PRODUCT UPDATE

CG03130 - 6FT 18 AWG UNIVERSAL POWER CORD (NEMA 5-15P TO C13)

What Has Changed?

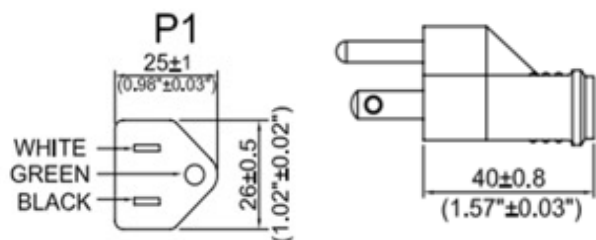
1. The **NEMA 5-15P connector** now features a minor visual update, with **double lines around the pins**.
2. The **NEMA 5-15P connector dimensions** have been adjusted from **40mm $\pm$ 0.8mm x 26mm $\pm$ 0.5mm x 25mm $\pm$ 1mm (LxWxH)** to **38mm $\pm$ 1mm x 21mm $\pm$ 0.4mm x 23.6mm $\pm$ 0.4mm (LxWxH)**.
3. The **temperature rating** has been upgraded from **75°C to 105°C** to comply with the latest **UL and CUL standards**.
